DEVIATION REQUEST AND DECISION FORM

Project Name: Sterling Ranch Sand Creek Channel Construction Drawing Review CDR 20-4

A deviation from the standards of or in Section <u>ECM section 3.3.3 Open Channel Design Standards</u> of the Engineering Criteria Manual (ECM) is requested for the Sand Creek Channel Design – Channel Perimeter Fencing.

Fencing Detail

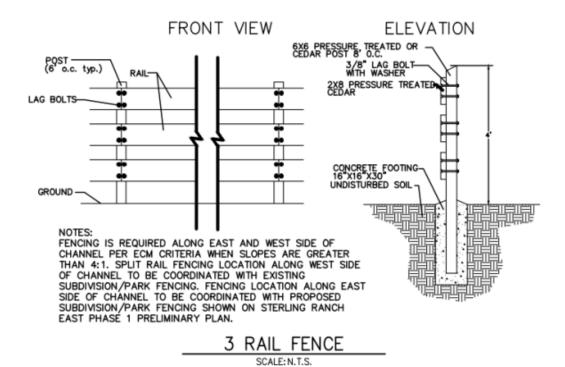
When the above condition is met, Fencing shall be chain link, a minimum of 6 feet in height with a top rail and vinyl coated for natural color compatibility (green or brown)
State the reason for the requested deviation: Sterling Ranch is requesting to use a more aesthetically pleasing split rail fence design as shown in exhibit A
Explain the proposed alternative and compare to the ECM standards (May provide applicable regional or national standards used as basis):
The vast majority of the channel side slopes or 4:1 or flatter, however in some isolated areas a 3:1 slope is necessary and those areas will require fencing. When that condition exists Sterling Ranch proposes to use split rail fencing similar to the detail shown in Exhibit A.

LIMITS OF CONSIDERATION (At least one of the conditions listed below must be met for this deviation request to be considered.)
 ☑ The ECM standard is inapplicable to the particular situation. ☐ Topography, right-of-way, or other geographical conditions or impediments impose an undue hardship and an equivalent alternative that can accomplish the same design objective is available and does not compromise public safety or accessibility. ☐ A change to a standard is required to address a specific design or construction problem, and if not modified, the standard will impose an undue hardship on the applicant with little or no material benefit to the public.
Provide justification:
Sterling Ranch is master planned development with open space areas and parks which have utilized the more aesthetically pleasing spilt rail fencing. The Sand Creek corridor acts as a regional open space corridor, the access road on western side of the channel will also function as a regional trail and the majority of the east side abuts a community park and open space tracts. To install chain link fencing would be visually obtrusive.
